Final Versatile Test Reactor Environmental Impact Statement

Comment Response Document

Figure 1. Ratio of the revised Federal Guidance Report (FGR) 13 thyroid dose conversion factors (DCF) to the original Department of Energy (HUDUFACT.dat) thyroid DCF for radionuclides having the largest increases. (PNNL-22827)

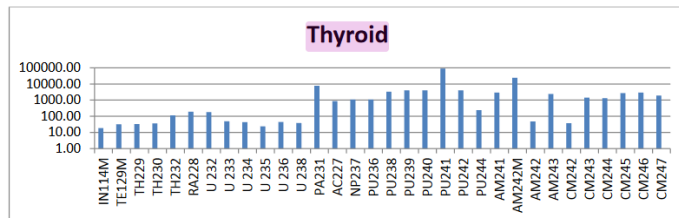
A 2013 Pacific Northwest National Laboratory (PNNL) report incorporating Federal Guidance Report 13 tabulated whole body and organ specific dose conversion factors for an average half-male and half-female at various ages.¹⁴ The 2013 PNNL report is to be used for calculating radiation dose but not the risk of higher radiation risks recognized in the EPA's 1999 Federal Guidance Report 13. Buried near the end of the PNNL report is a chart of how wildly increased the thyroid cancer incidence was for various radionuclides, by a factor of 10, of 100, of 1000, of 10,000 and of 100,000! See Figure 1.

The radionuclides in Figure 1 include thorium, uranium and uranium decay progeny, plutonium, curium and americium. The thyroid cancer incidence rate increases for plutonium-238, plutonium-239, plutonium-240, plutonium-241 and americium-241 is over 1000.

**23-76
cont'd**

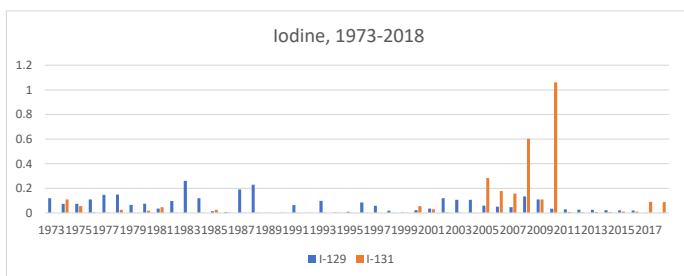
Then let's take a look at the iodine-129 and iodine-131 releases between 1973 and 2017, in curies. The State of Idaho DEQ went from displaying all of their environmental monitoring reports to displaying ten years of the reports, to now displaying only six years of annual reports and only 4 years of quarterly data reports from 2013 to 2018. **Again, here you can see why the Idaho DEQ didn't want to display INL monitoring data before 2013.**

23-73 Environmental monitoring is performed at all DOE sites including INL. The monitoring programs record and document the impacts of activities at each site. Information about monitoring may be found in the Annual Site Environmental Reports (ASER) for each location via the following link: <https://www.energy.gov/ehss/downloads/asere-links>. Information presented in the ASERs complies with DOE Order 231.1B, "Environment, Safety and Health Reporting," and the INL Site Environmental Monitoring Plan is in compliance with DOE Order DOE Order 458.1, "Radiation Protection of the Public and the Environment." This VTR EIS presents the most recent information available on the current environment at the INL Site. The concerns expressed by the commenter regarding the current monitoring program and the determination of the source of existing contamination (e.g., strontium, cesium, and other radionuclides in the marmot tissue samples) at the INL Site are not within the scope of this EIS.

Photo 1. A photo from Artist-in-Residence Matt Dieterich of the celebrated stargazing potential at Craters of the Moon.

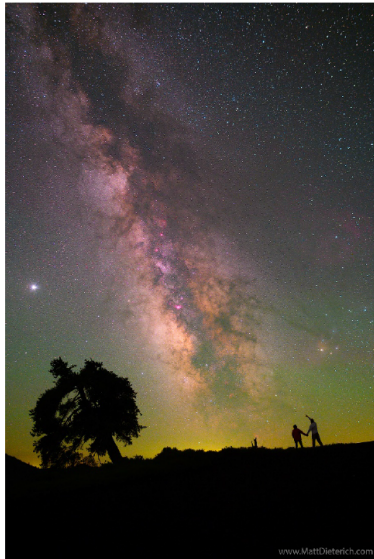
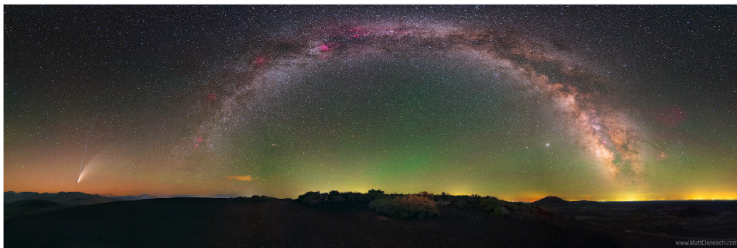
left in the lower 48 with exceptional darkness with the majestic sweep of the Milky Way regularly evident over the sere landscape. The photos below illustrate the beauty and power of the dark skies above Craters of the Moon.

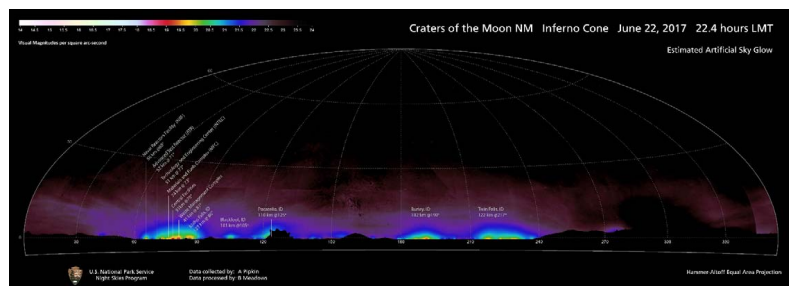
We strongly encourage night sky impacts to Craters of the Moon to be included in Chapter 5: Cumulative Impacts in the final EIS. Calibrated hemispheric light pollution measurements taken from near Craters of the Moon headquarters detail the exact location and impact of anthropogenic lights as observed from the park (Figure 1). Data from the National Park Service Natural Sounds and Night Skies Division (NSNSD) show that, overall, Craters of the Moon has excellent night sky conditions. When considering the entire hemisphere as observed from the park, average sky brightness is just 19.5% brighter than natural conditions. Overhead, sky brightness is truly natural, but conditions degrade closer to the horizon.

Finally, color photographs such as Photo 3 taken within the park illustrate the impact that light domes have on the visual scene. The Milky Way shines in the southern horizon but is lost to the light domes of Arco. Taken together, the data and images document the incredible night sky resources of Craters of the Moon but also highlight resource degradation. In such a naturally dark region, even very small sources of anthropogenic light can dramatically change the landscape. The topography of the area is such that unshielded lights and scattered light can travel for hundreds of kilometers.

Figure 3. A regional map of anthropogenic light ratio (ALR) derived from visible infrared imaging radiometer suite (VIIRS) satellite data illustrating the spatial distribution and intensity of light pollution, expressed in a ratio over natural conditions, around Craters of the Moon.

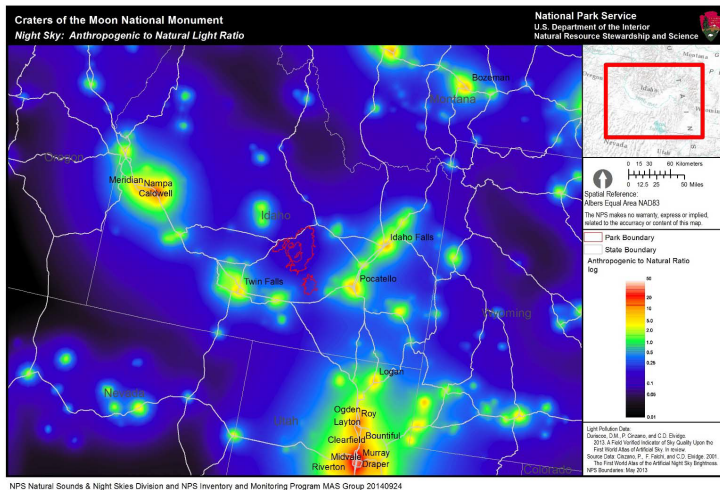
Calibrated satellite data can also be used to map the extent of skyglow at a landscape scale. Using data from the New World Atlas of Light Pollution, we can measure the all-sky light pollution ratio (ratio of artificial to natural light for the whole hemisphere for one observation point). When assessing regional light pollution around Craters of the Moon, the contribution of light from INL facilities is readily apparent (Figure 3). The all-sky light pollution ratio over INL

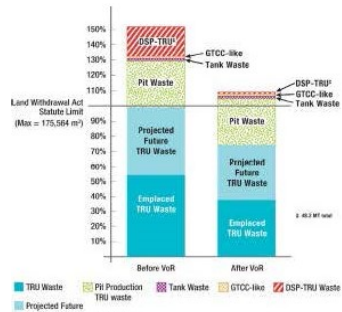
Because of not using permitted capacity, WIPP also does not have room for all of the legacy TRU waste that was supposed to go to WIPP. The NAS Report Figure S-5 shows that the legacy TRU amounts to about the legal capacity limit before the Volume of Record (VOR).

Given the unused capacity in panels 1-7, there is not room for all of the legacy TRU waste. Thus, to allocate any space for the 34 MT of surplus plutonium or VTR waste would mean that very substantial amounts of legacy defense TRU waste would remain at the storage sites. The WIPP Permit currently states that disposal ends in 2024,¹⁰ while the VTR is to operate for 60 years, much beyond the WIPP lifetime. In its NEPA documents, NE must recognize those facts.
